Access Compliance Report

Public Rights-of-Way

| Intersection ID: 53899 | Main Street: LANGWELL_LN | Cross Street: ELGIN_MOOR_RD | Location: SW |
| ADA ID: 01219417177B | Ramp Type: Perp | Initial Pass/Fail: Fail | Overall Compliance: No |

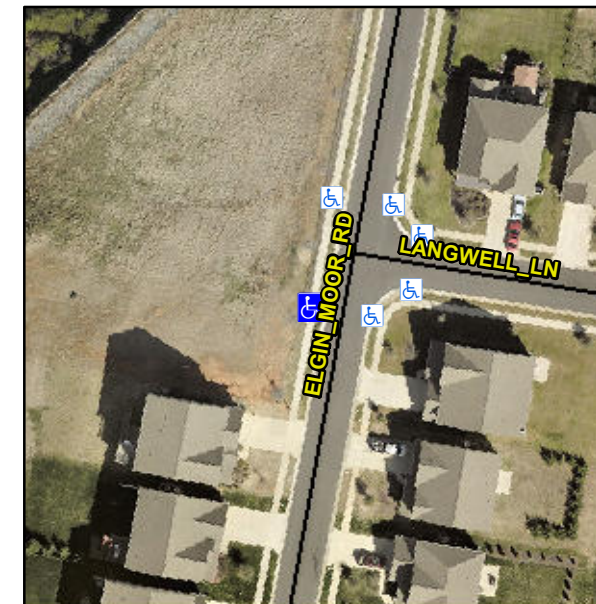
Not Found, R304.5.1, R304.5.3

| Compliance | Description | Data | Compliance | Description | Data |
|------------|-----------------------|-------|------------|-----------------------------|------|
| No | Ramp Width (in) | 47.5 | No | Ramp XSlope (%) | 6.0 |

Remove & Replace Entire Ramp.
